MANDATORY SERVICE BULLETIN

NO. MSB-42-042/1

I.4 Subject

Installation of additional ECU Backup Batteries to supply electric power solely to the ECU in the course of high transient causing a short term voltage drop in case of insufficient main battery power.

Figure 10a

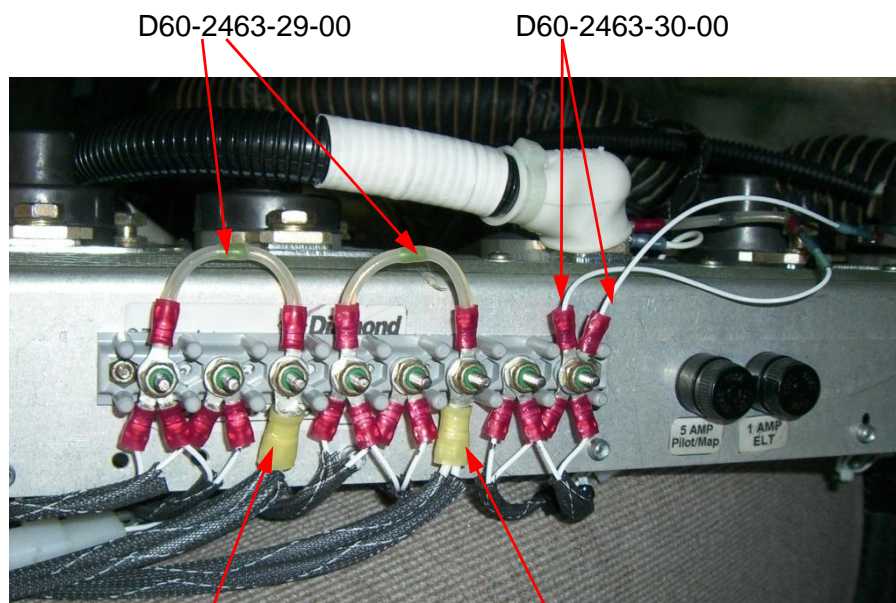
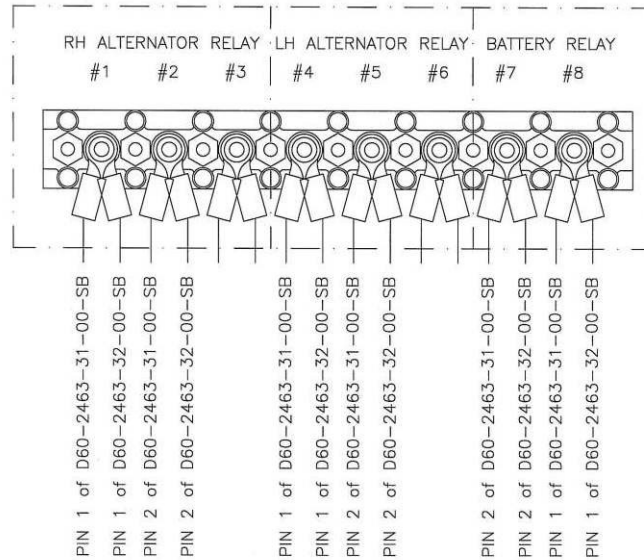
- 14 Connect the ring terminals of the 6 adapter harnesses (D60-2463-31-00-SB and D60-2463-32-00-SB), the fuse assemblies (D60-2463-29-00), the wires 24315A14/24317A14, part of D60-2463-24-00, the wires 24316A14/24318A14, part of D60-2463-25-00 and the cable, diode assemblies (D60-2463-30-00) to the terminal block as shown below.

Figure 26

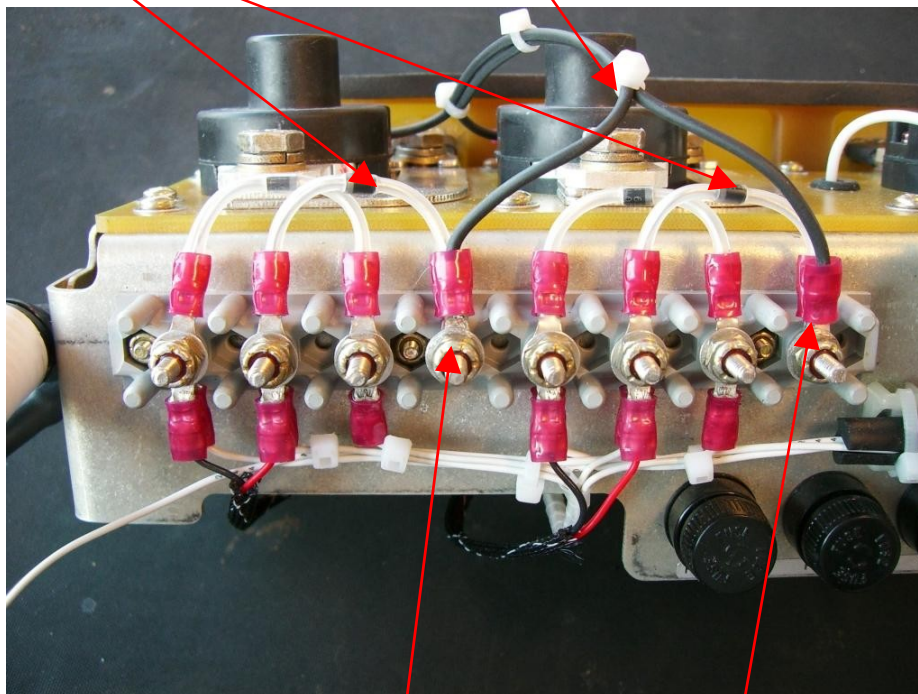
- 17 If the airplane is equipped with an oxygen system, remove the main battery and remove the oxygen bottle in accordance with the AMM, Section 35-10.
- 18 Drill a hole (maximum 65mm diameter) into the mounting bracket of the oxygen bottle to gain access to the terminal block mentioned in the steps below.

CAUTION: Insert a sheet metal or equivalent between the bracket and the relay panel to avoid damage to the relay panel.

DA 42 Twin Star	Drawing Number: D60-2463-21-00	
"a"	MÄM 42-240a	12.07.07	Kowarsch			
".."	MÄM 42-240	18.04.07	Kowarsch			
Rev.	Change	Date	Name	Saved under : D60-2463-21-00a.dft

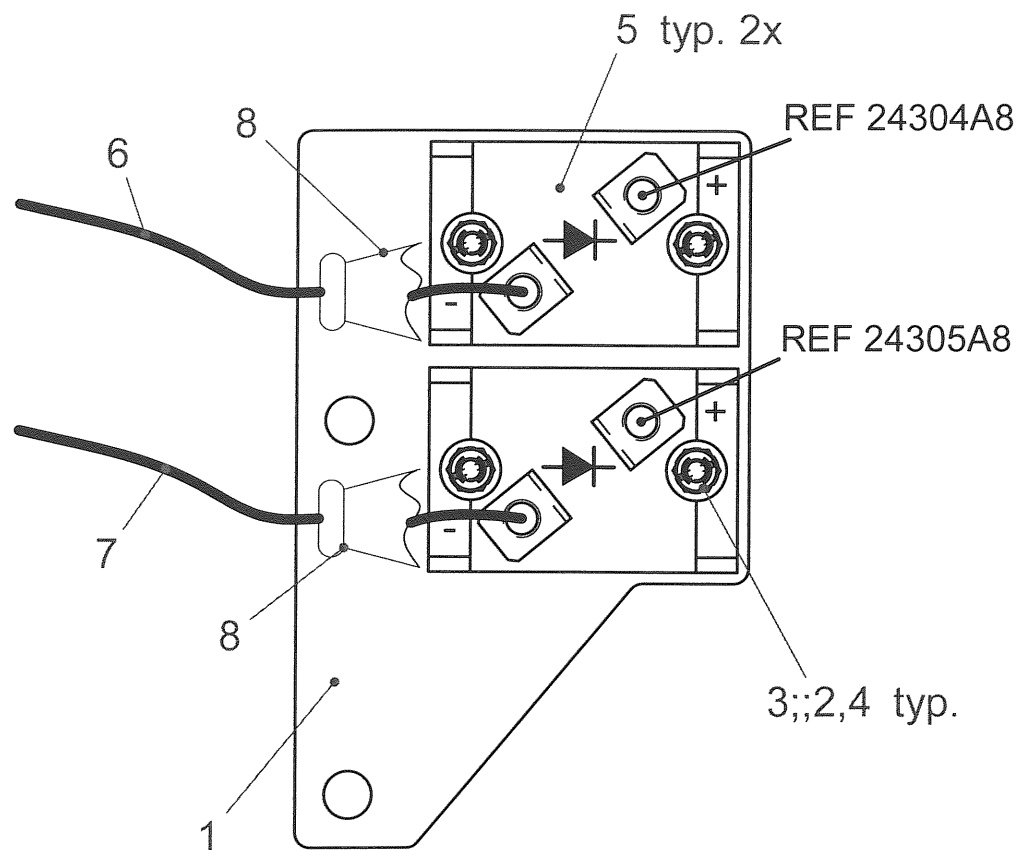
8	2	-	MS25171-1S	Insulating Boot		
7	1	-	D60-2463-23-00	RH Relay/Diode Cable		Diamond
6	1	-	D60-2463-22-00	LH Relay/Diode Cable		Diamond
5	2	-	395-9163	Diode, T70HF40		RS Components
4	4	-	DIN 985-M3-A2	Locknut		
3	4	-	DIN 963-M3x10	Screw		
2	4	-	DIN 125A-3.2-A2	Washer		
1	1	-	D60-2463-21-01	Mounting Bracket, Diodes		Diamond Aircraft
Pos.	QTYL	QTYR	Part Number	Description	Specification	Supplier
Approved: R. Kremnitzner Date 27. JULI 2007 Name			Checked: M. Kowarsch Date 23. JULI 2007 Name		General Tolerance : ISO 2768 medium 	Scale: 1:1
				Next Higher Assembly : D60-2463-00-00	Title : Diode Assembly

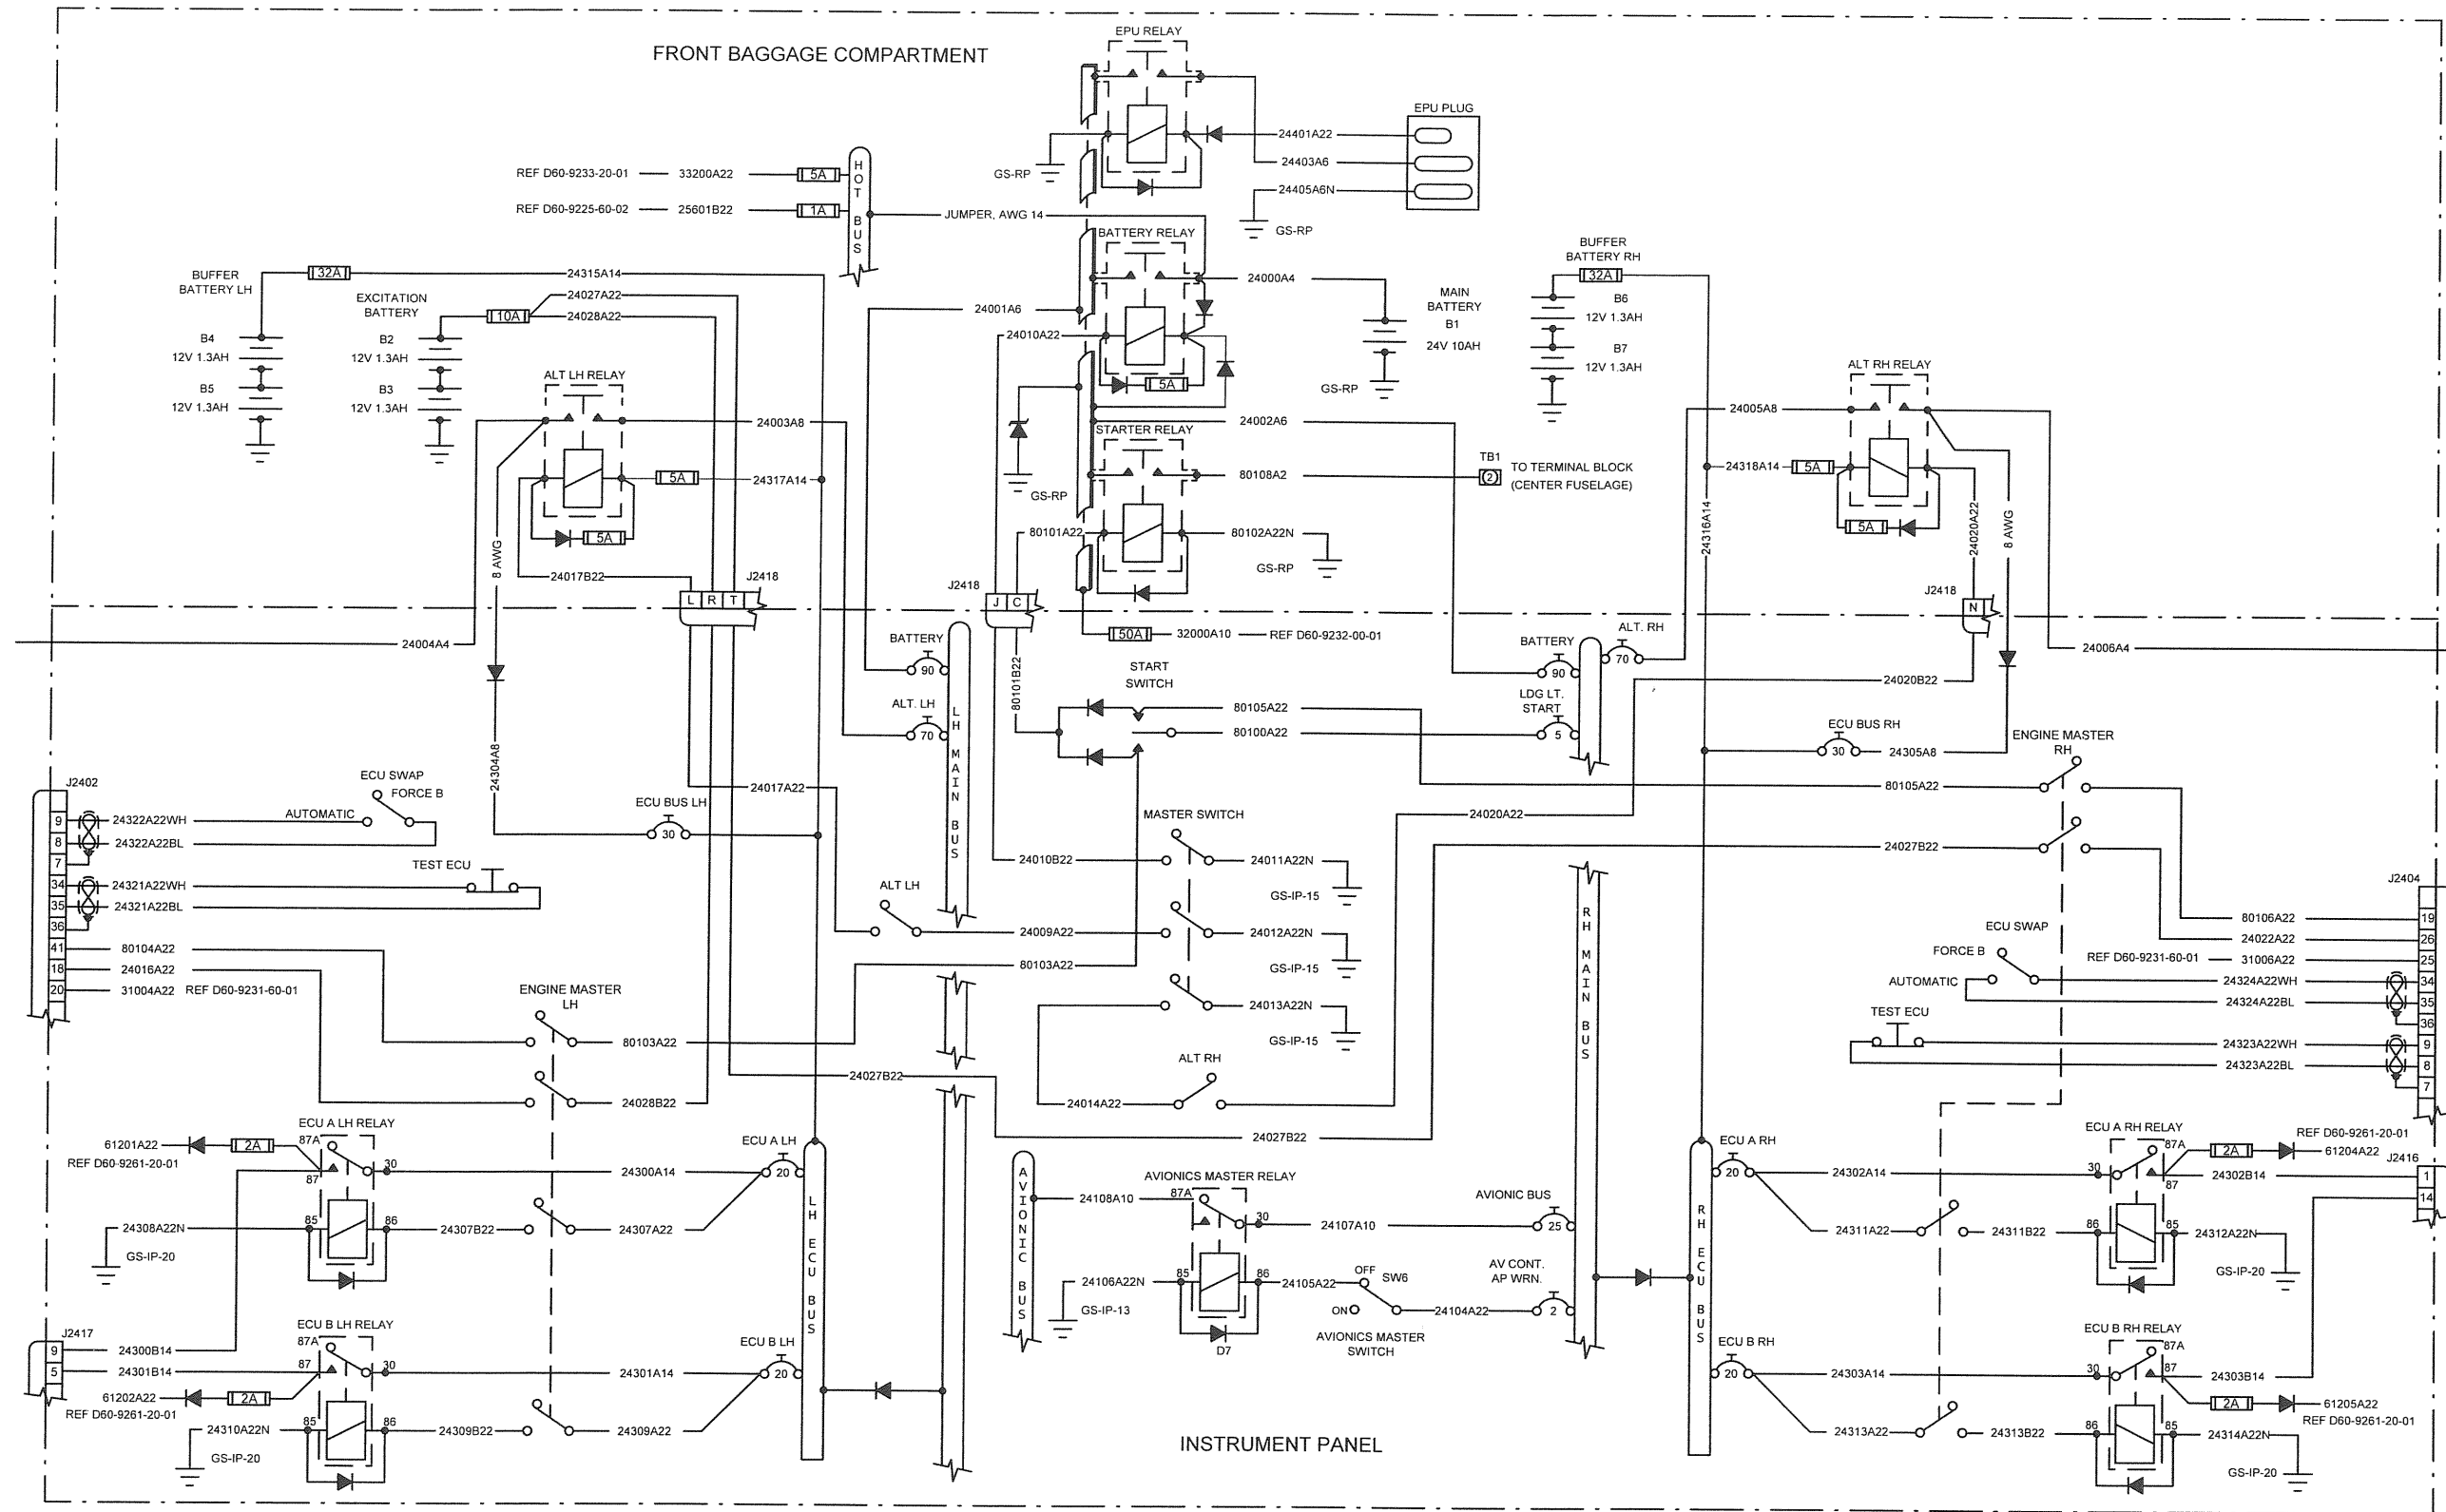
- 21 Replace the positive coil connection of the battery relay with the "Cable, diode assembly" D60-2463-30-00. Note the polarity of the diode. Refer to drawing D60-9224-30-01-SB, D60-9224-30-02-SB or D60-9224-30-02_02 and also to figure 28.
